environmental statement

THREE MILE ISLAND NUCLEAR STATIC
UNITS 1 and 2

DOCKET NOS. 50-289 and 50-320

December 1972

Figure 10 - VENTILATION SYSTEM, THREE MILE ISLAND NUCLEAR STATION UNIT 2

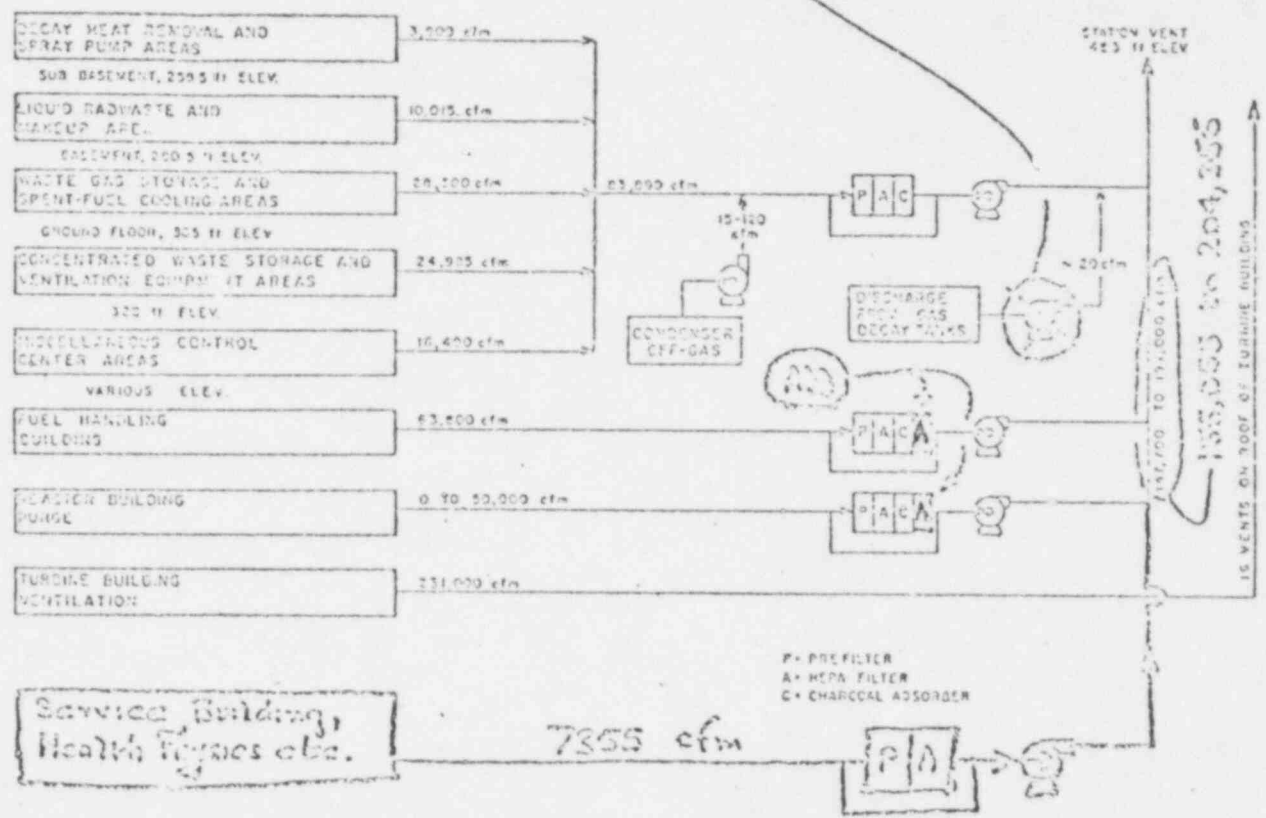
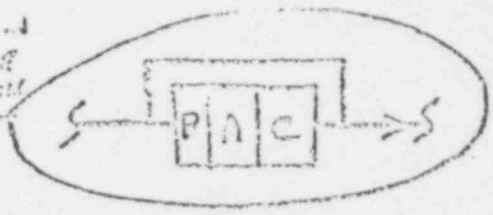
3. Figure 10, Ventilation System, Three Mile Island Nuclear Station Unit 2, on Page III-11 should be revised as shown on the attached sketch.
4. Figure 12, Liquid Radioactive Waste Treatment System, Three Mile Island Units 1 and 2, on Page III-14 should be revised to indicate the capability to direct the Powdex sluice water and the deep bed resins and effluent to the radwaste system as shown on the attached sketch.

DELETE FAN...
 & ADD FILTER
 ASSY AS SHOWN

Figure 1

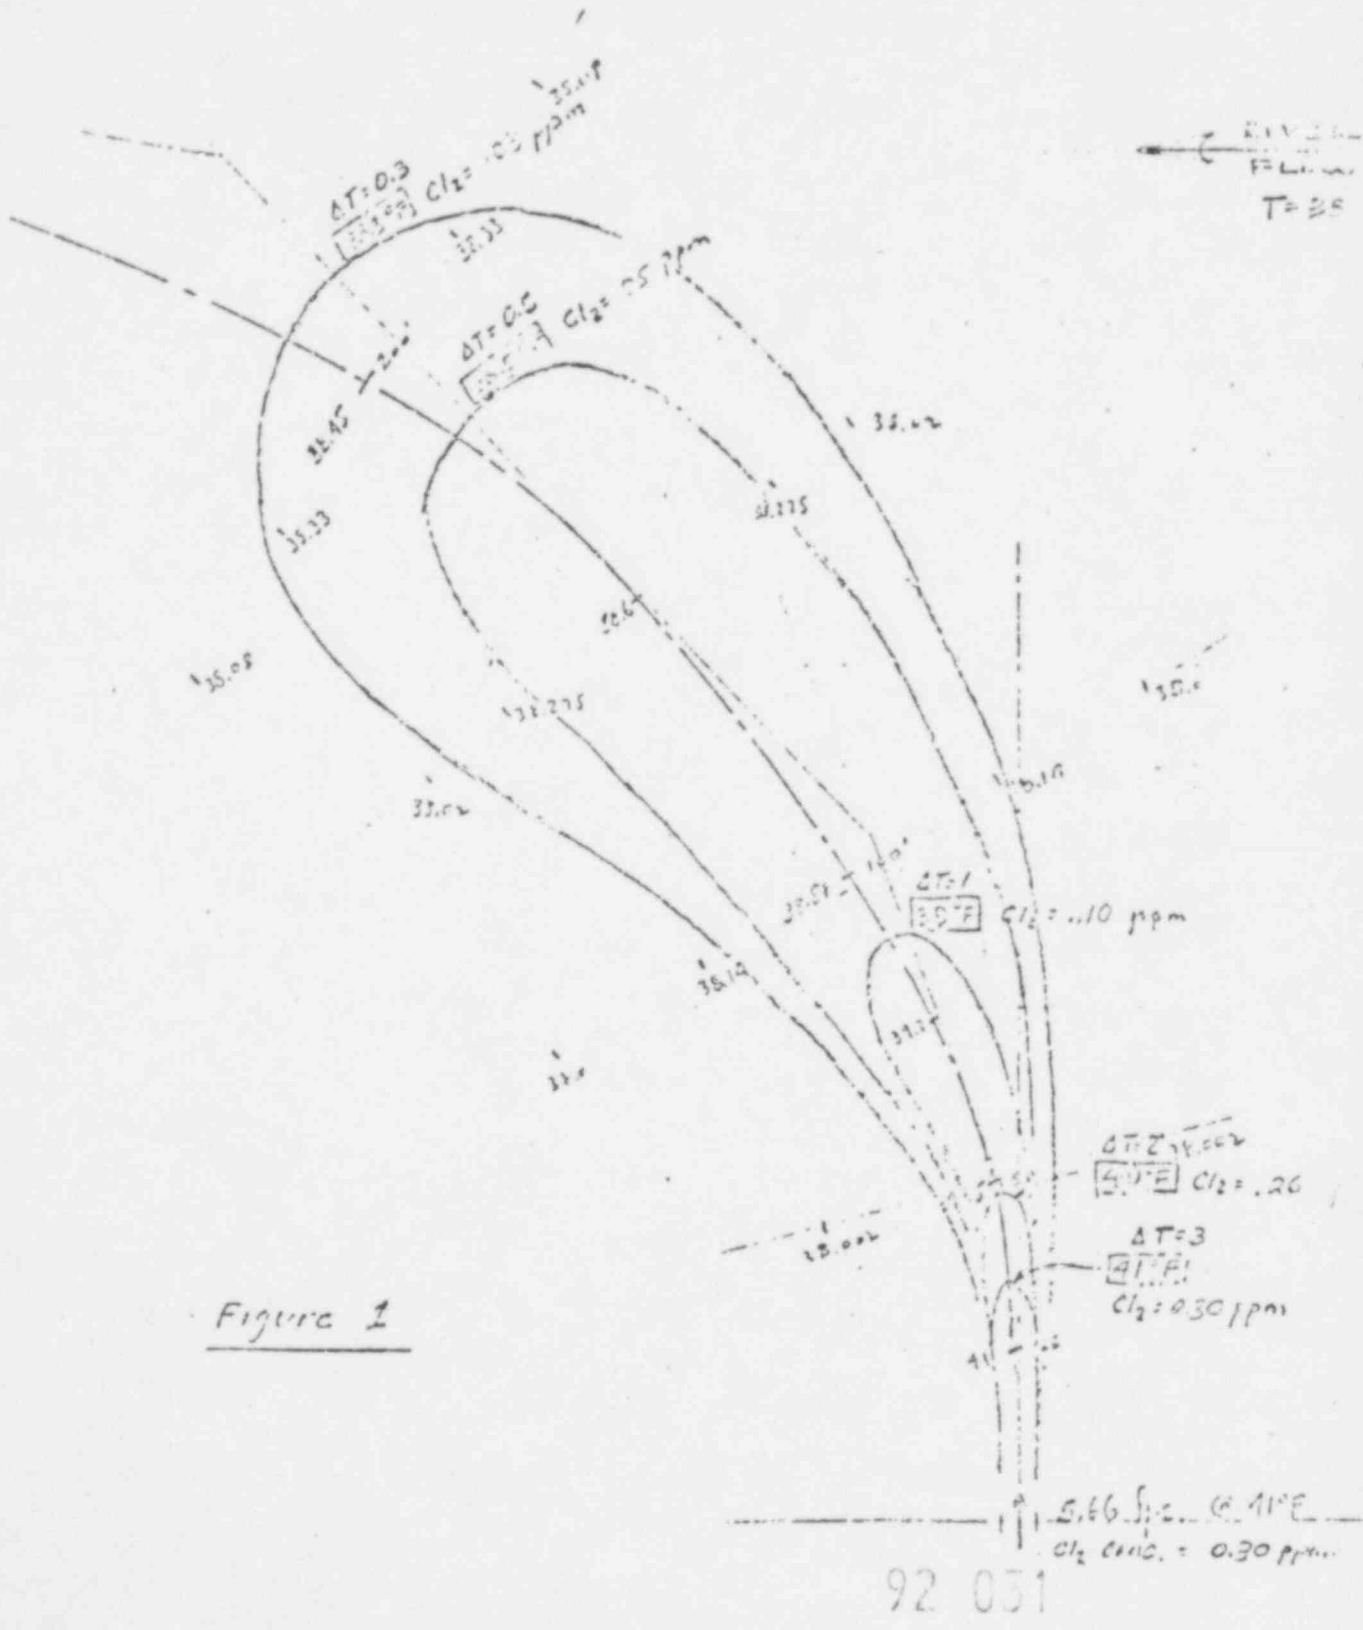
Cooling tower effluent is discharged continuously and, therefore, the plume shown in Figure 1 represents steady state conditions. The magnitude of the plume may be described in terms of the dimensions of the river and island. At the point of discharge the river is 1200 ft. wide, while the

plume, as defined by the 10 dilution contour, projects only 200 ft. into the river. The plume extends downstream about 120 ft. as compared to the length of Three Mile Island which is about 12,000 ft. The conditions of cooldown are, however, time dependent. The plumes resulting from these transient conditions are presented in Figures 2 and 3. Initially the cooldown flow is at a ΔT of 12.0°F (Figure 2). This temperature reduces to 3°F within 12 hrs. (Figure 3). The plumes under these conditions are not significantly larger than the tower effluent plume. The plume extends about 225 ft. into the river and about 220 ft. downstream.

It can be seen in reviewing Figure 1 that substances will undergo 10 dilutions in about 220 ft. of plume travel. The cooling water discharge at a $\Delta T = 12^\circ\text{F}$ (Figure 2) reaches 10 dilutions after about 300 ft. of travel. The cooling water discharge at a ΔT of 3°F (Figure 3) reaches 10 dilutions after about 250 ft. of travel.
